<b>Workshop and Service</b>	<b>Valid for:</b>	<b>USA Pavers</b>
	<b>Machine type:</b>	<b>F1000T Track Paver</b>
	<b>S/N°:</b>	<b>All Teir III US Track Pavers</b>
	<b>Valid from (date):</b>	<b>11/13/2012</b>
	<b>SI-N°:</b>	<b>SI-121113-0001</b>
	<b>Subject:</b>	<b>Accumulator Replacement and Precharge</b>
	<b>Part Number</b>	<b>D717090502</b>

SI-N°: SI-121113-0001

Fig.1 The structure of diaphragm accumulator

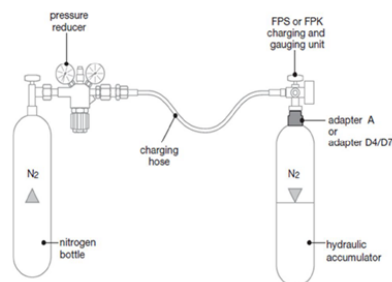
1. Remove valve protection and valve seal caps (where applicable).
2. Attach appropriate HYDAC charging and gauging unit (Model Code: FPK 250 F2.5 G4 K) to the accumulator by following the instructions in the HYDAC Charging and Gauging Units manual #02068202. (See fig.2) Prior to connecting the charging and gauging unit to an accumulator, close manual bleed valve by hand tightening. Connect the unit to the accumulator by screwing cap nut onto HYDAC gas valve version 1(FPK). Hand tightens.

4. If gas precharge pressure is too low, continue charging; refer to HYDAC Charging and Gauging Units manual #02068202.
5. If gas precharge is too high, it can be reduced by carefully opening the manual bleed valve and relieving some pressure (see fig.3). Release the gas precharge pressure very slowly until the desired gas precharge pressure is reached 2160 psi, disconnect the charging and gauging unit from the accumulator. Check for leaks; NONE are permissible. Torque valve seal cap (see torque requirements below) and hand tighten valve protection cap (where applicable).
